**Proposal #19: 1060-33-83  
Zoo IC, Ped Bridge Over USH 45  
At Wauwatosa West HS  
USH 45  
Milwaukee**

This is Addendum No. 1, which provides for the following:

**ADDENDUM NO. 1**

**1060-33-83**

Addendum No. 1  
ID 1060-33-83  
Revised Sheet 316  
May 5, 2015

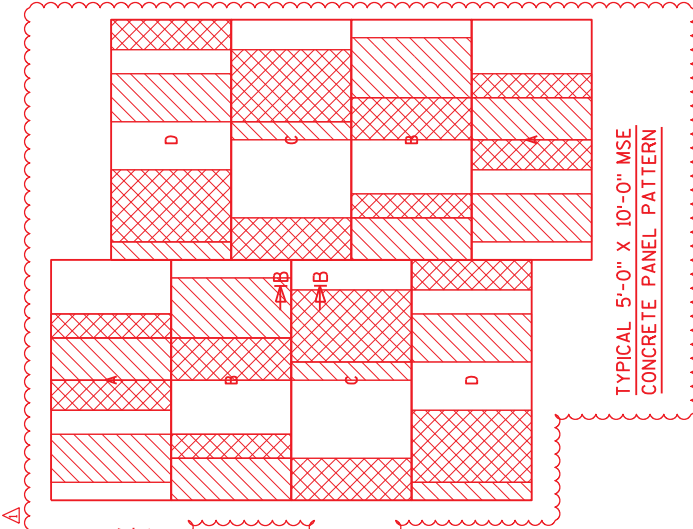
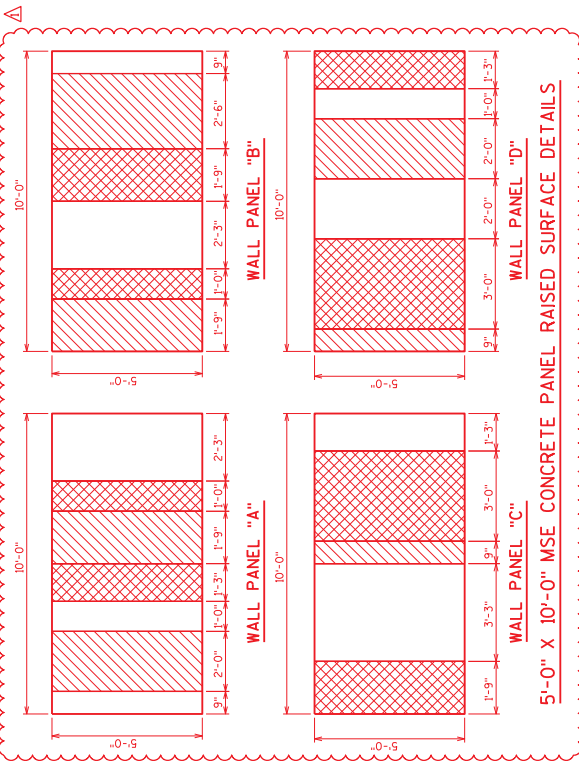
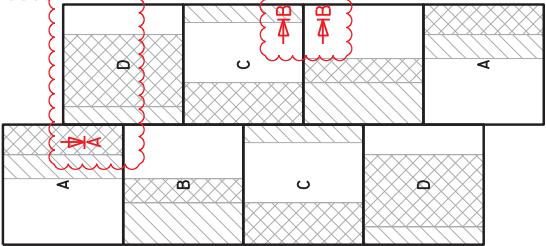
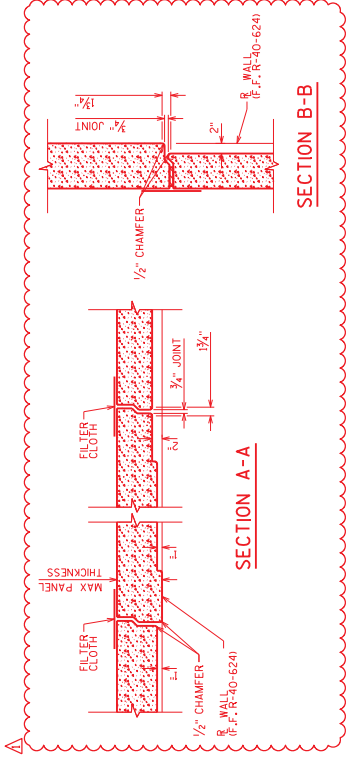
Revised Plan Sheets	
Plan Sheet	Plan Sheet Title (brief description of changes to sheet)
316	Structure R-40-624 – Aesthetic Details – Added panels and relief changes
317	Structure R-40-625 – General Plan & Elevation 1 – Changes to list of drawings and sheet numbers
327	Structure R-40-625 – Aesthetic Details 1 – Added panels and relief changes.
328	Structure R-40-626 – General Plan & Elevation 1 – Changes to list of drawings and sheet numbers
339	Structure R-40-626 – Aesthetic Details 1 – Added panels and relief changes.

NO.	DATE	REVISION	BY
1	4/20	MSE PANEL REVISIONS	NAR
<i>William C. DeLoe</i> 4/30/15			
STATE OF WISCONSIN DEPARTMENT OF TRANSPORTATION STRUCTURES DESIGN SECTION			
STRUCTURE		R-40-624	
DRAWN BY	DDS	PKAS	AJBS
CHECKED BY			
AESTHETIC DETAILS			316
SHEET II

Addendum No. 1  
ID 1060-33-83  
Revised Sheet 327  
May 5, 2015

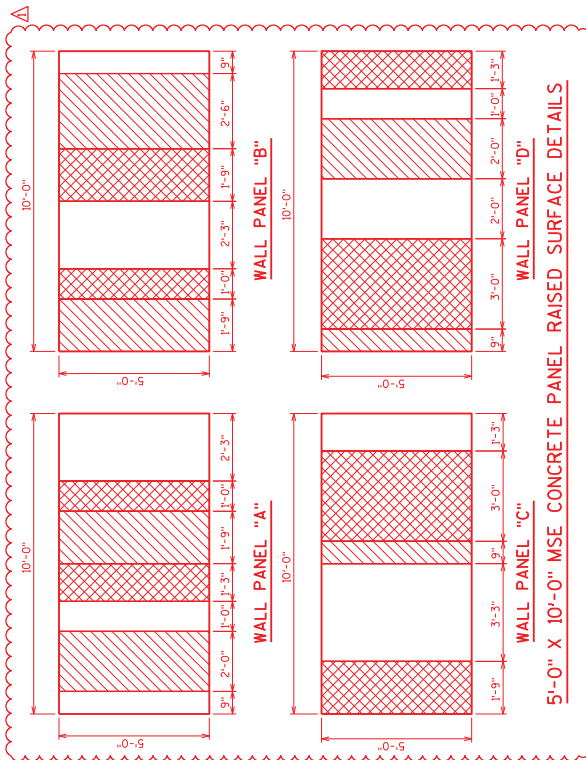
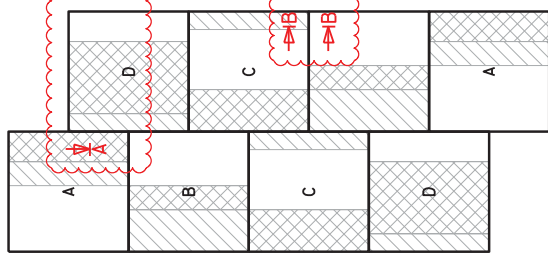
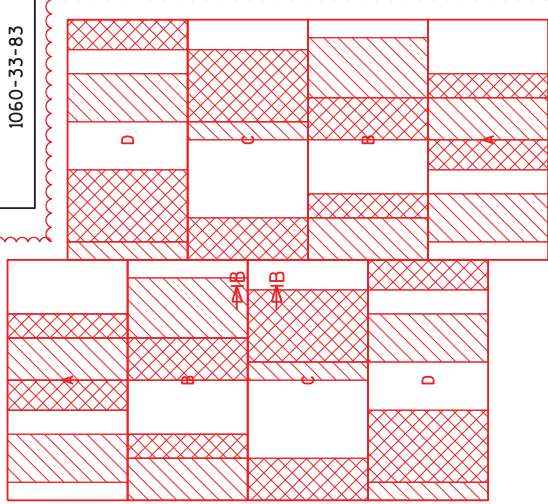
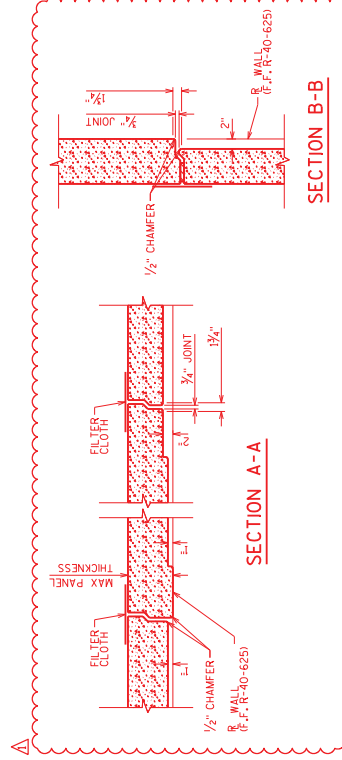
NO.	DATE	MSE PANEL REVISIONS	REVISION	BY
4/20				
STATE OF WISCONSIN DEPARTMENT OF TRANSPORTATION STRUCTURES DESIGN SECTION				
STRUCTURE R-40-625				
DESIGNED BY	DD	D	DD	DD
DRAWN BY	DD	D	DD	DD
SHEET II				
327

Addendum No. 1  
ID 1060-33-83  
Added Sheet 327A  
May 5, 2015

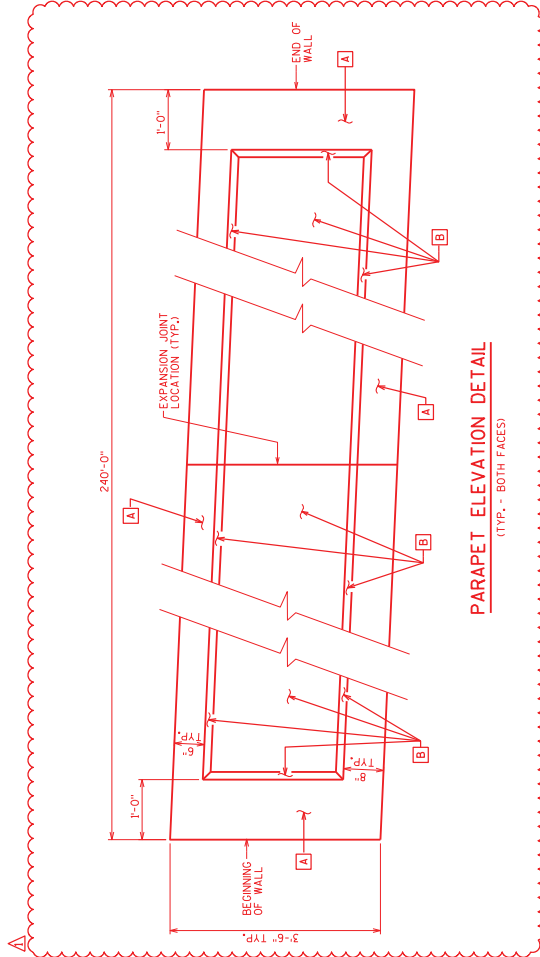
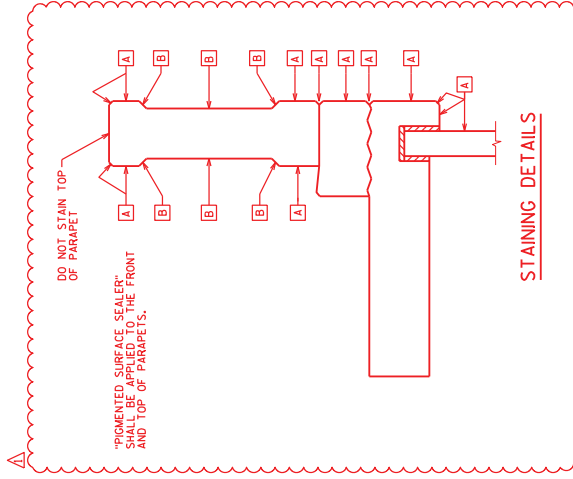
Added Plan Sheets	
Plan Sheet	Plan Sheet Title (brief description of why sheet was added)
327A	Structure R-40-625 – Aesthetic Details 2 – New sheet detailing aesthetics of parapet
339A	Structure R-40-626 – Aesthetic Details 2 – New sheet detailing aesthetics of parapet

Addendum No. 1  
ID 1060-33-83  
Revised Sheet 339  
May 5, 2015

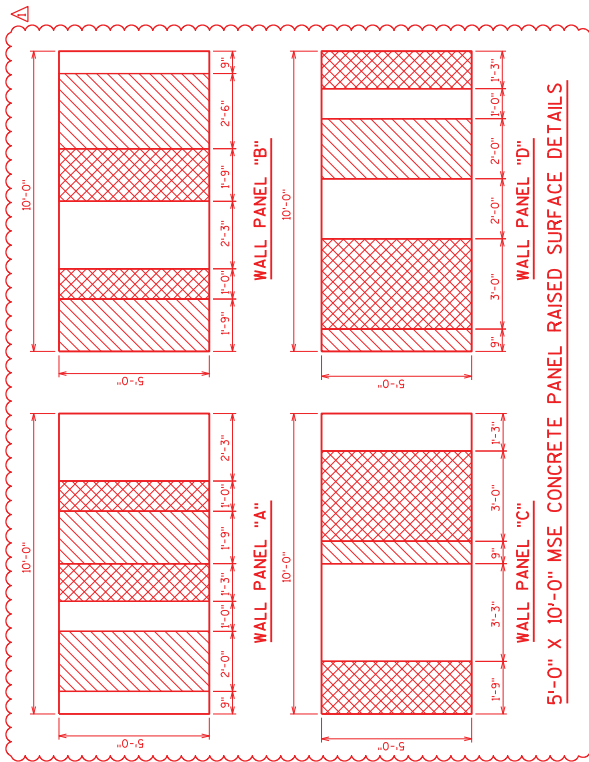
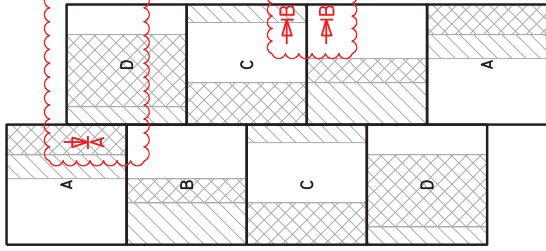
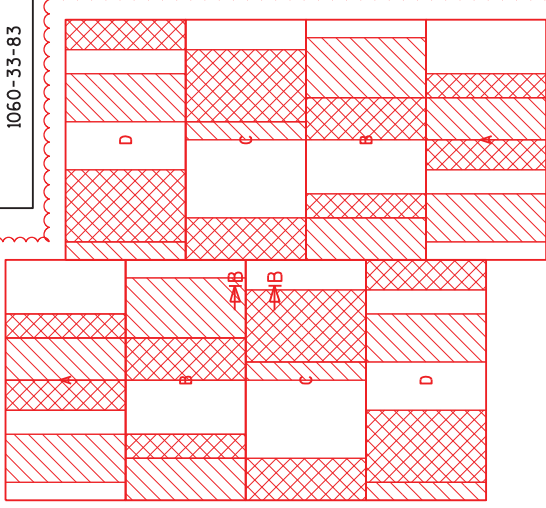
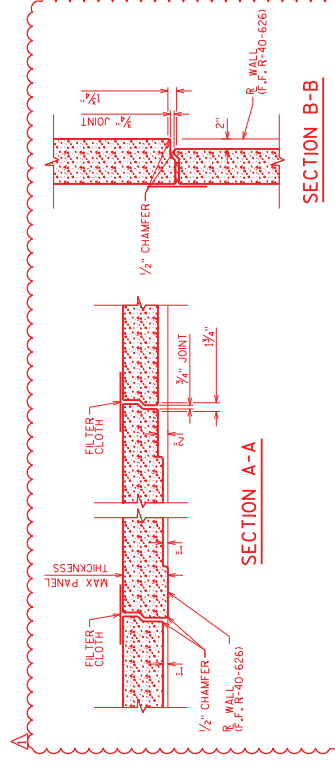
NO.	DATE	MSE PANEL REVISIONS	REVISION	BY
4/20
